Vermont Yankee Nuclear Power Station

Proposed Technical Specification Change No. 225

Missed Technical Specification Surveillance

Marked-up Version of the Current Technical Specifications

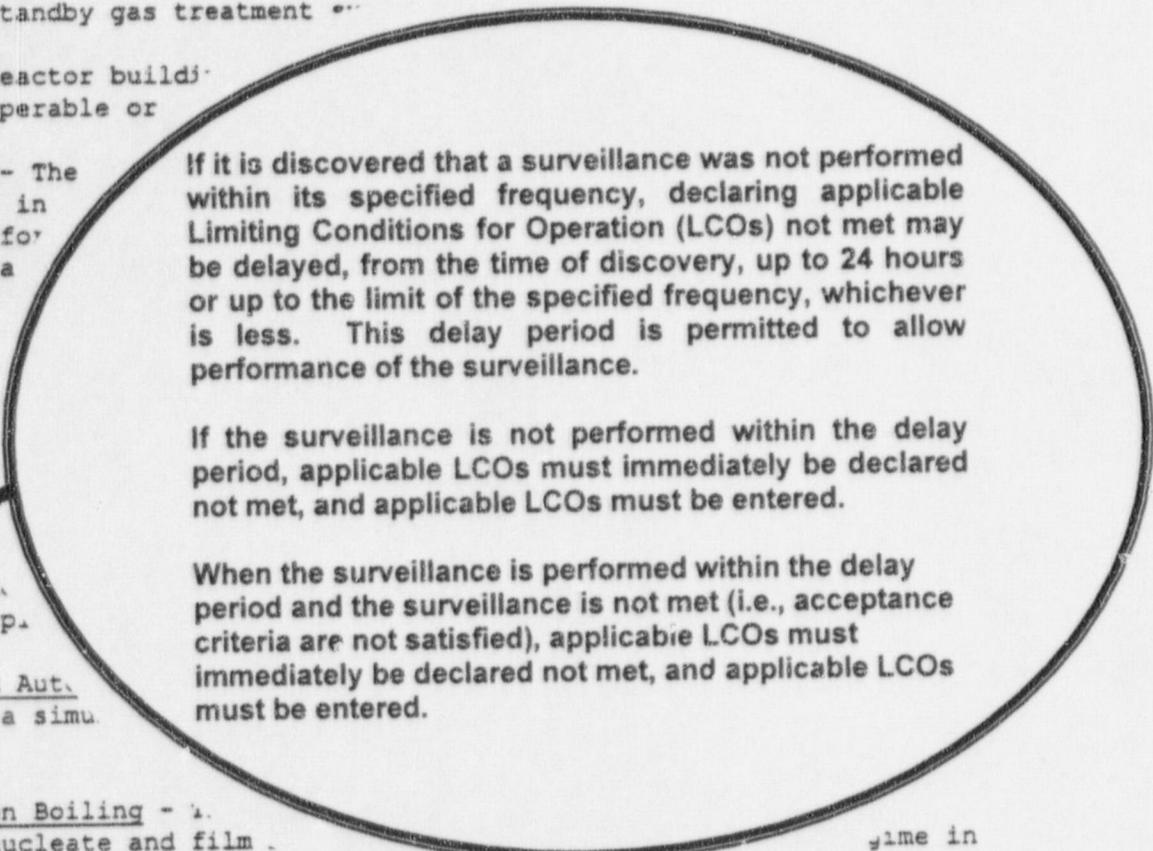
Y. Surveillance Frequency - Unless otherwise stated in these specifications, periodic surveillance tests, checks, calibrations, and examinations shall be performed within the specified surveillance intervals. These intervals may be adjusted plus 25%. The operating cycle interval is considered to be 18 months and the tolerance stated above is applicable.

If it is discovered that a surveillance was not performed within its specified frequency, declaring applicable Limiting Conditions for Operation (LCOs) not met may be delayed, from the time of discovery, up to 24 hours or up to the limit of the specified frequency, whichever is less. This delay period is permitted to allow performance of the surveillance.

If the surveillance is not performed within the delay period, applicable LCOs must immediately be declared not met, and applicable LCOs must be entered.

When the surveillance is performed within the delay period and the surveillance is not met (i.e., acceptance criteria are not satisfied), applicable LCOs must immediately be declared not met, and applicable LCOs must be entered.
